FINAL PLAT THE TRAILS FILING No. 10

A SUBDIVISION OF PORTIONS OF THE SOUTHWEST QUARTER OF SECTION 16 AND THE SOUTHEAST QUARTER OF SECTION 17,
TOWNSHIP 12 SOUTH, RANGE 64 WEST OF THE THE SIXTH PRINCIPAL MERIDIAN, COUNTY OF EL PASO, STATE OF COLORADO.

Sheet 1 of 5

PCD FILE No. SF-24-21

Sheet 3 of 5

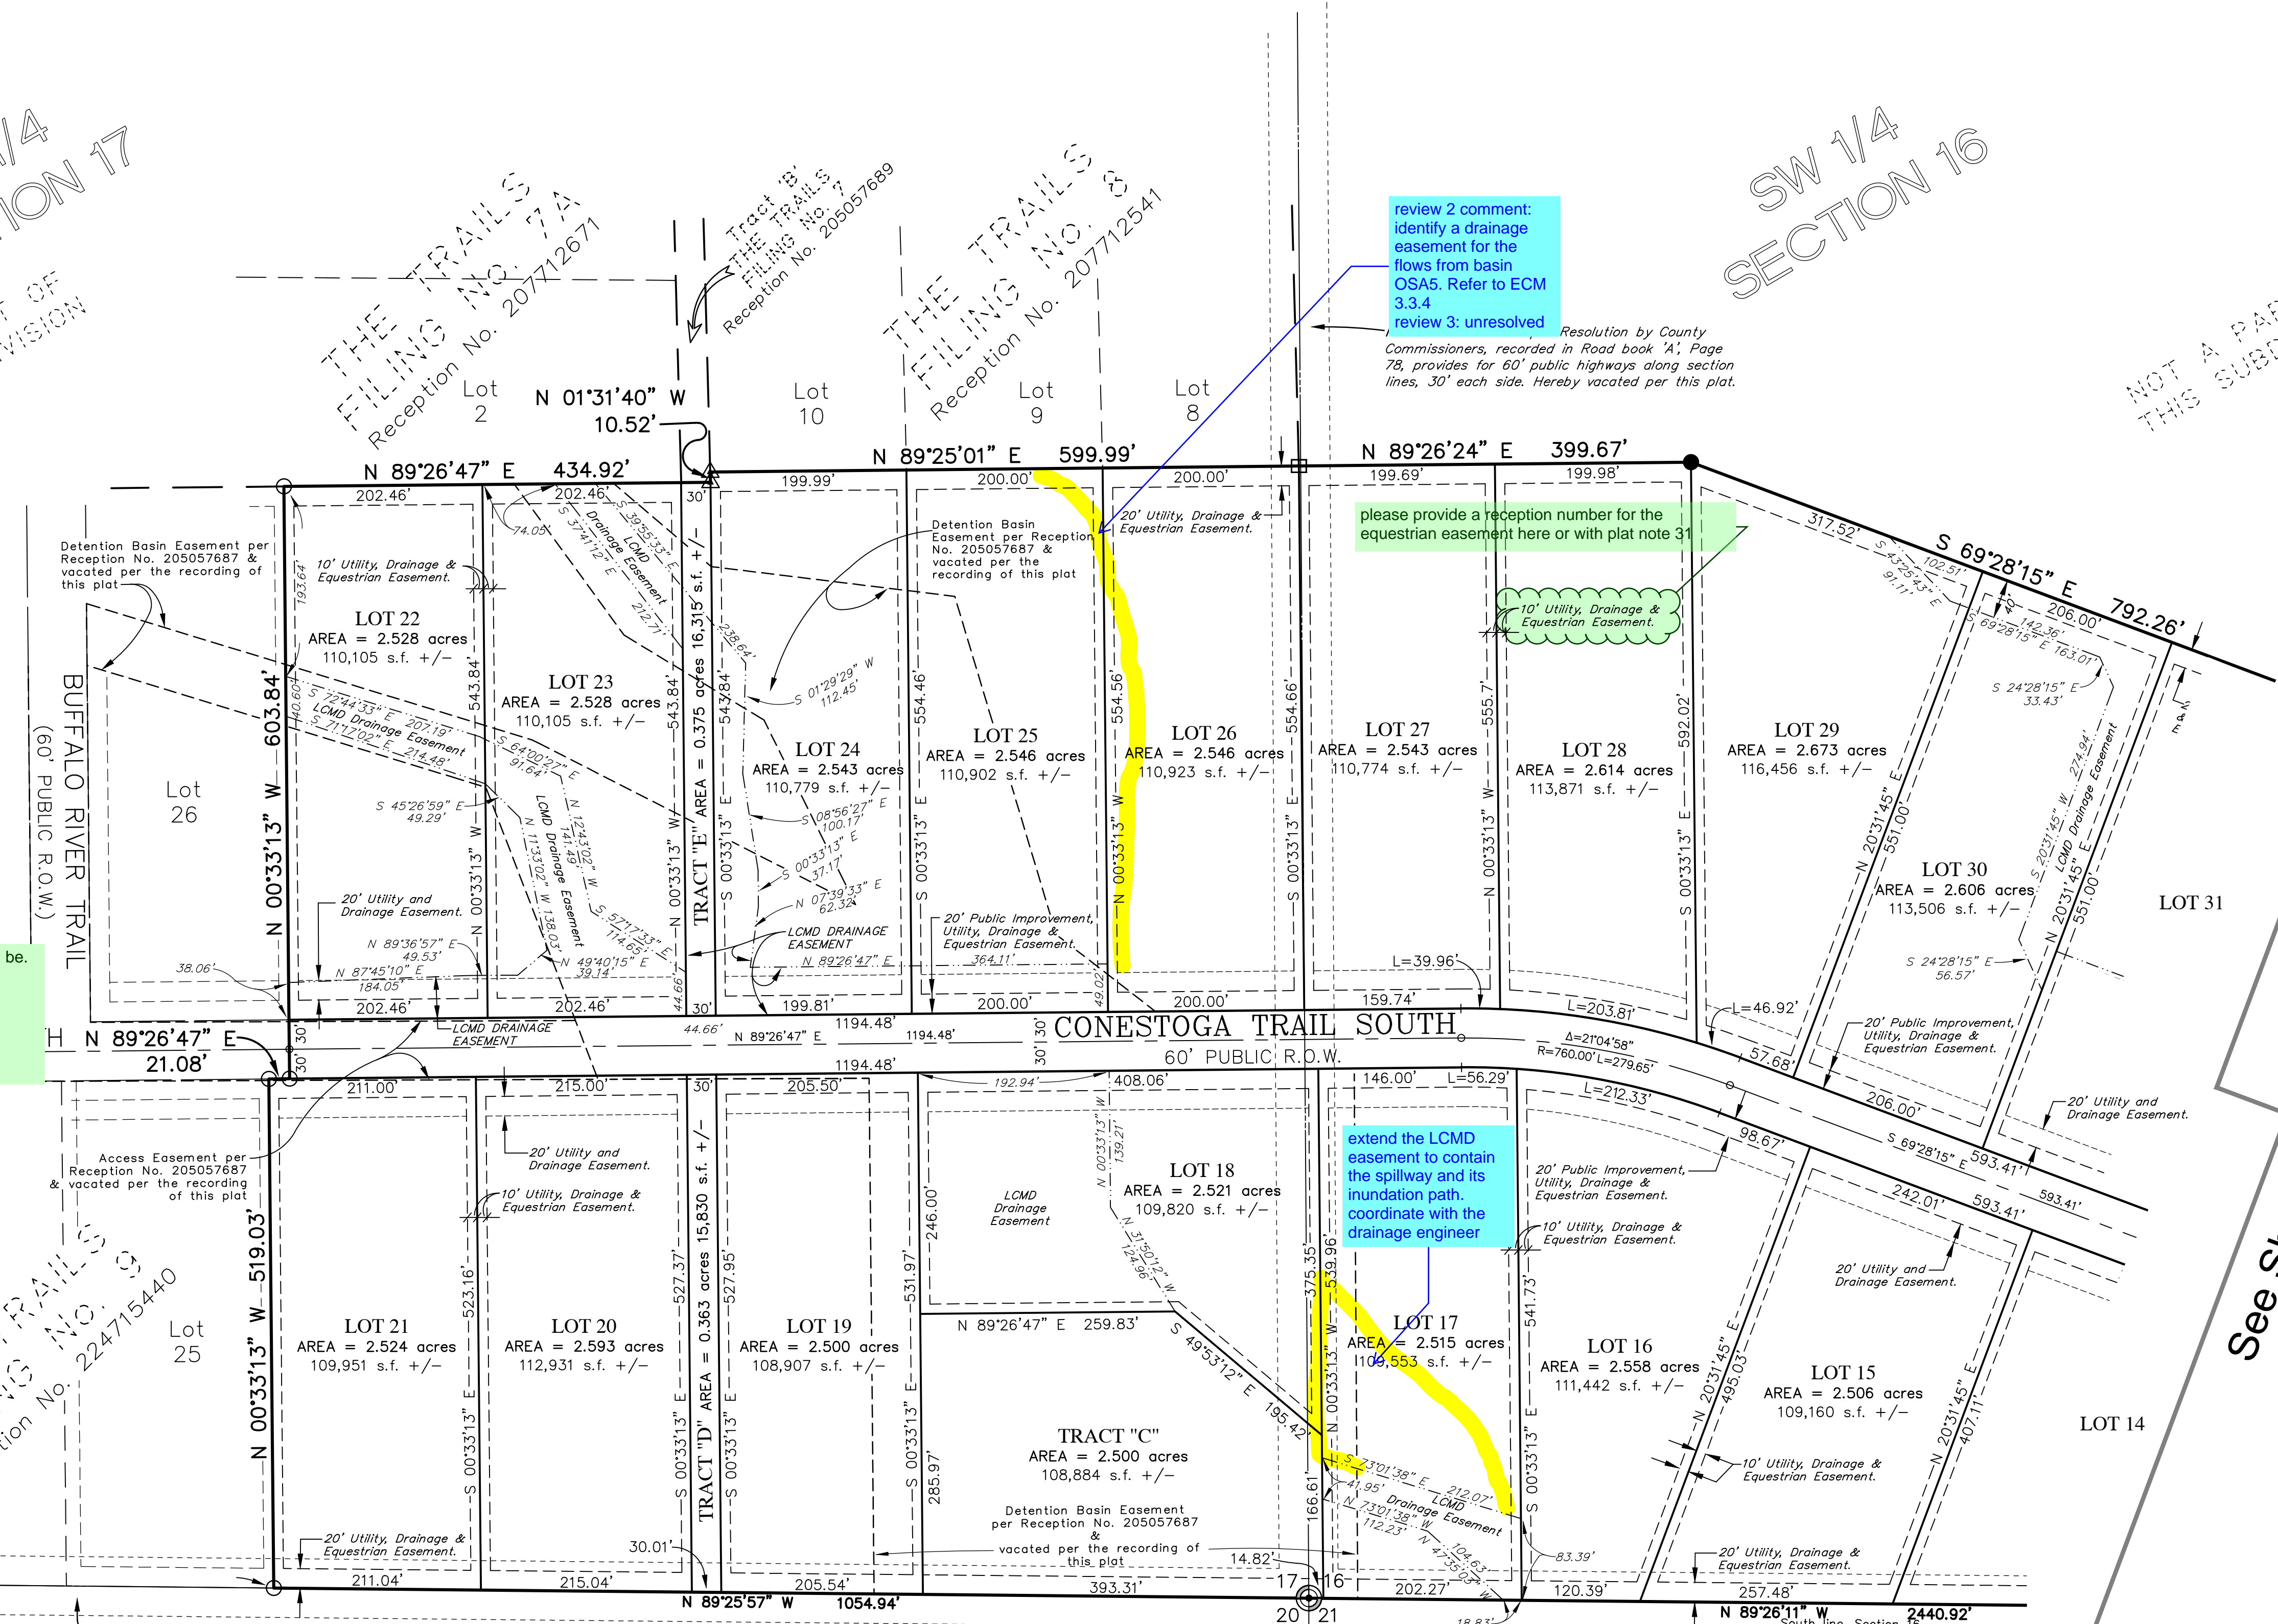
Fire hydrants will need to be implemented at the site. Please indicate where the fire hydrants will be.

Drainage easements are tied to no build areas, this should be depicted on the plat

Where is the trail easement that the Parks Dept requested?

review 2 comment:
identify a drainage easement for the flows from basin OSA5. Refer to ECM 3.3.4
review 3: unresolved

please provide a reception number for the equestrian easement here or with plat note 31

extend the LCMD easement to contain the spillway and its inundation path. coordinate with the drainage engineer

Sheet 5 of 5

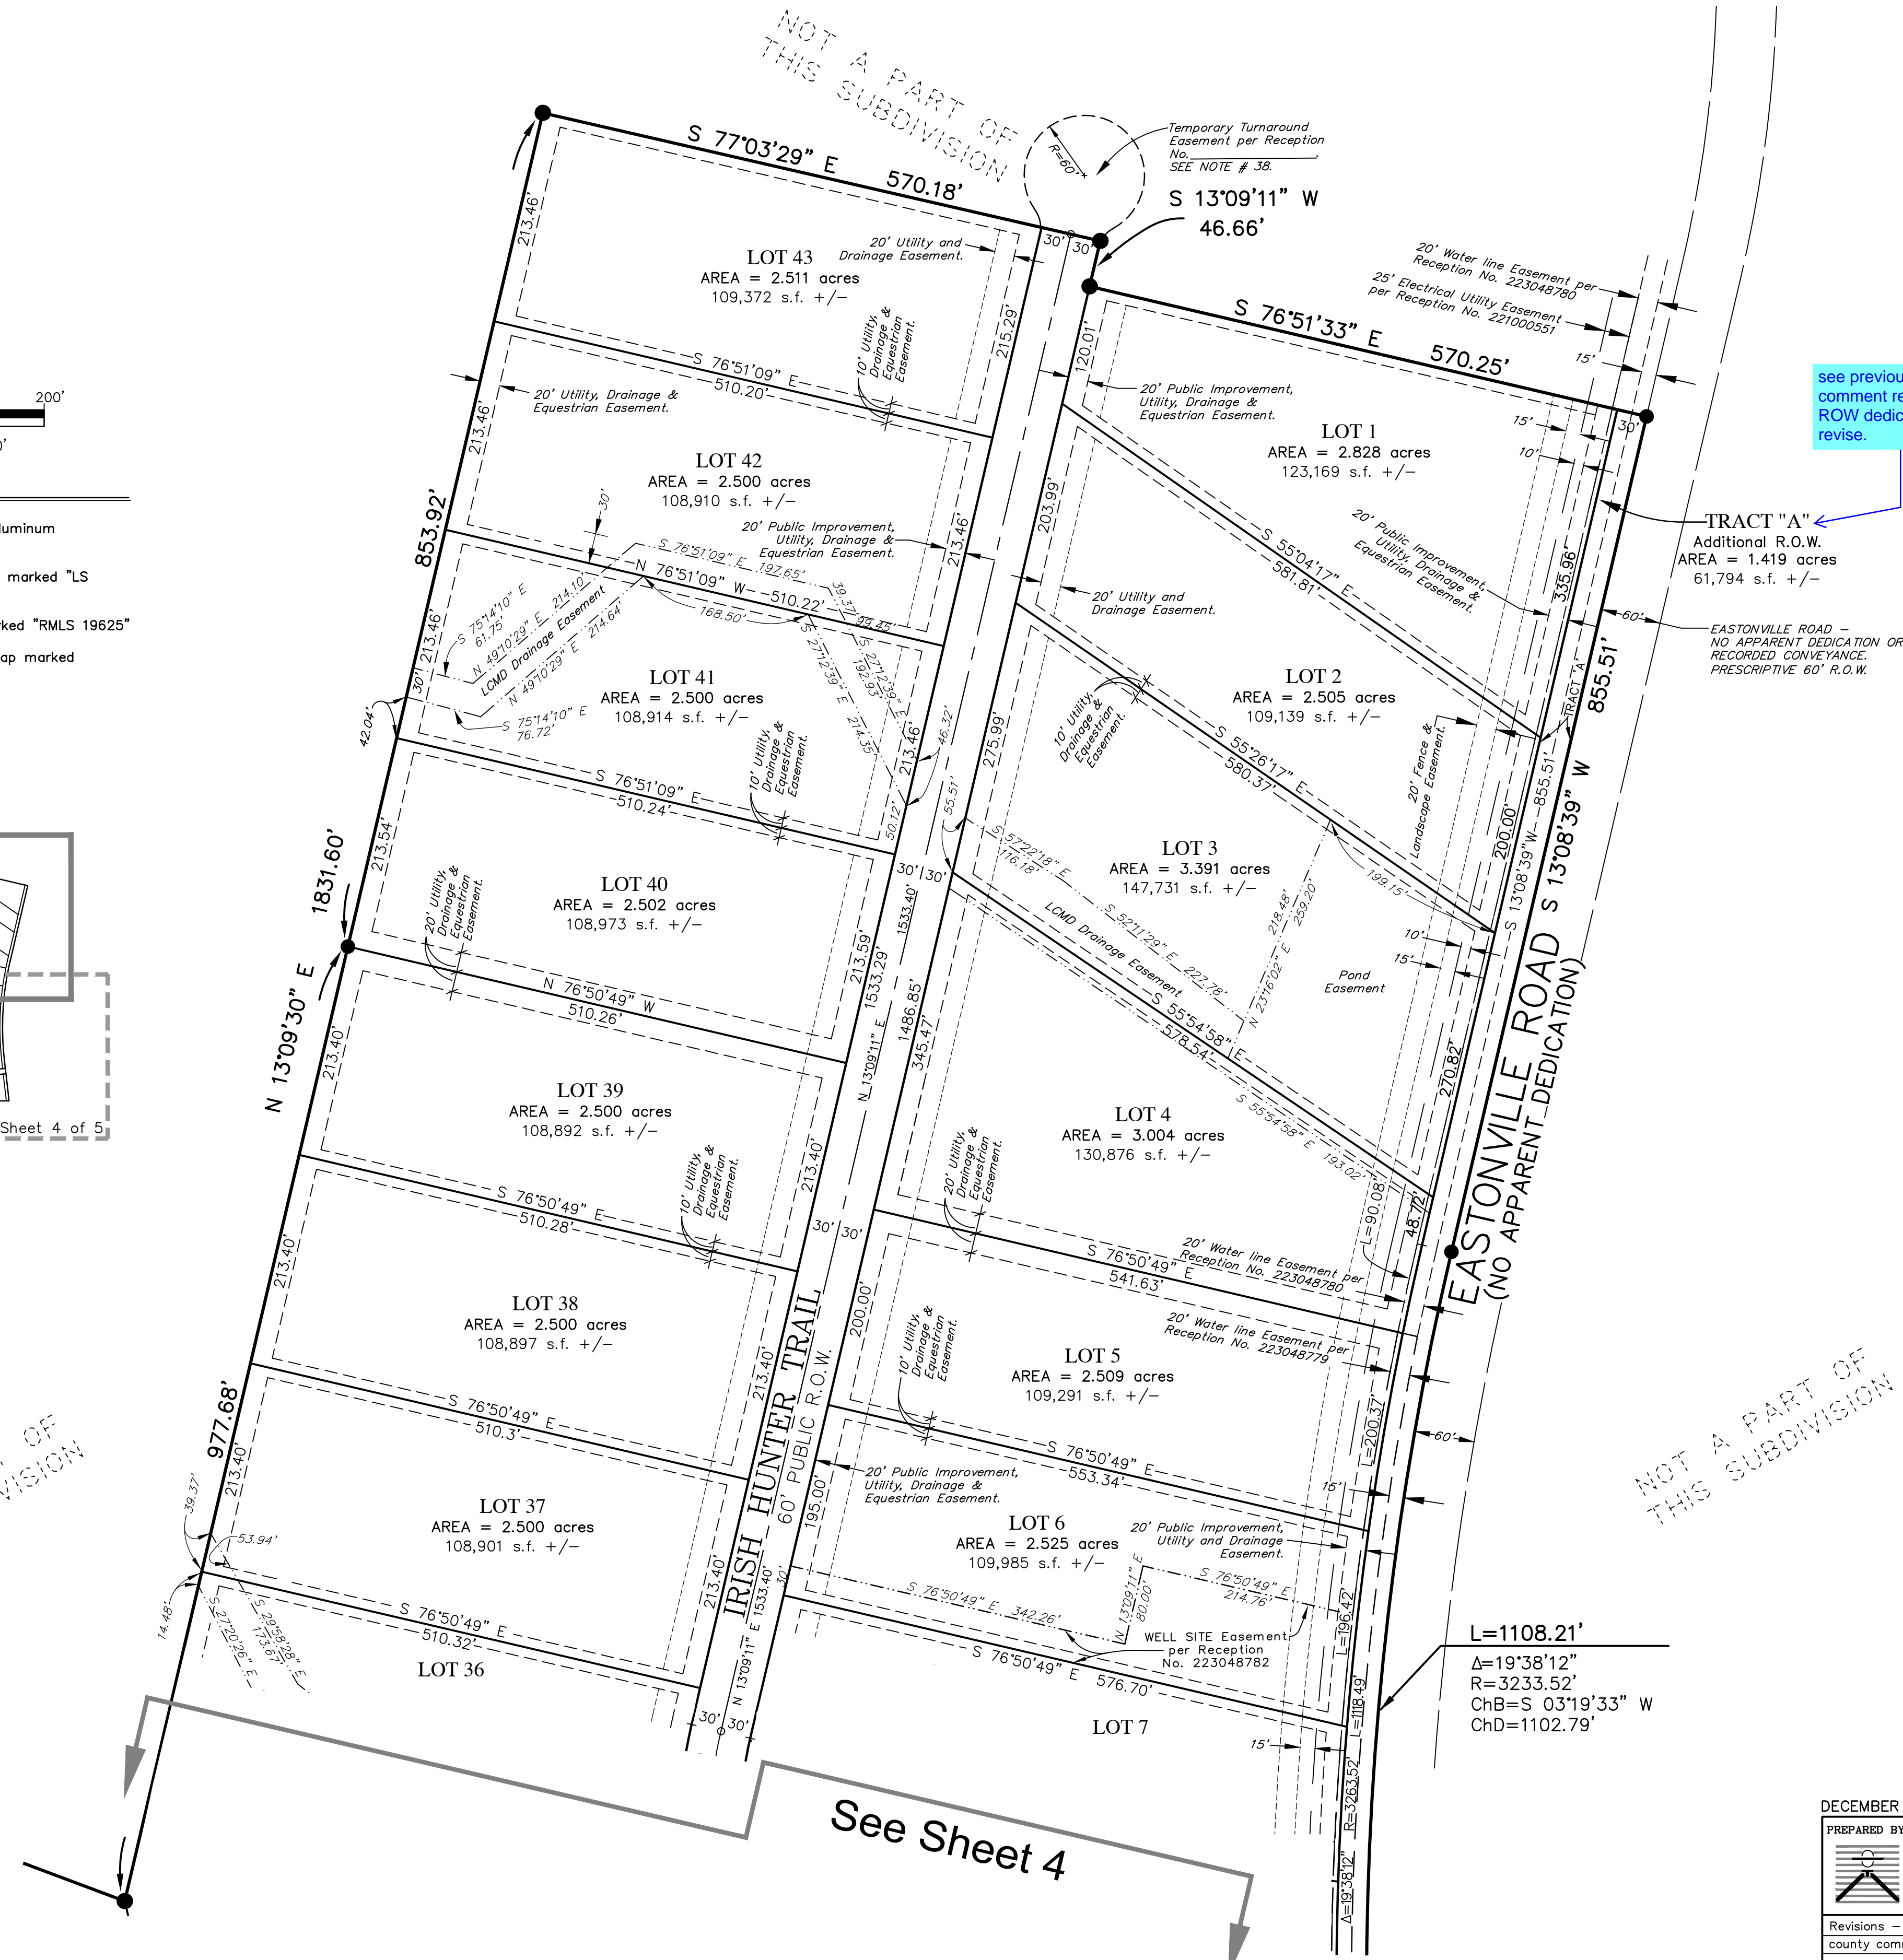
see previous
comment regarding
ROW dedication and
revise.
